Hi-Fi Products
Service Bulletin

Model: D-515

No. 314

Subject: Disc Does Not Rotate

(61)

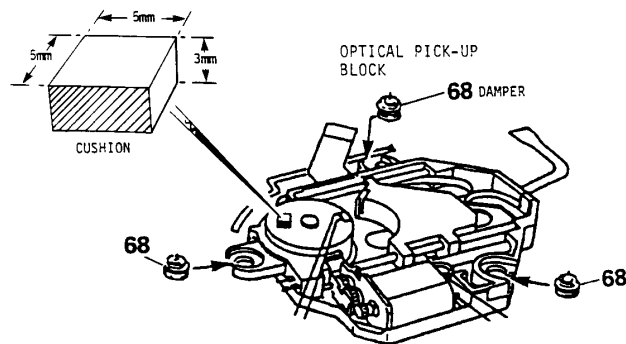
Broken dampers allow the chassis to drop too low into the lower cabinet. This causes the disc to contact the middle cabinet, preventing disc rotation.

Replace the dampers with an improved type. Install a cushion on the bottom of the CLV motor. The part number for the new dampers is the same as the part number for the original dampers, but the National Parts Center will only supply the new (black) dampers.
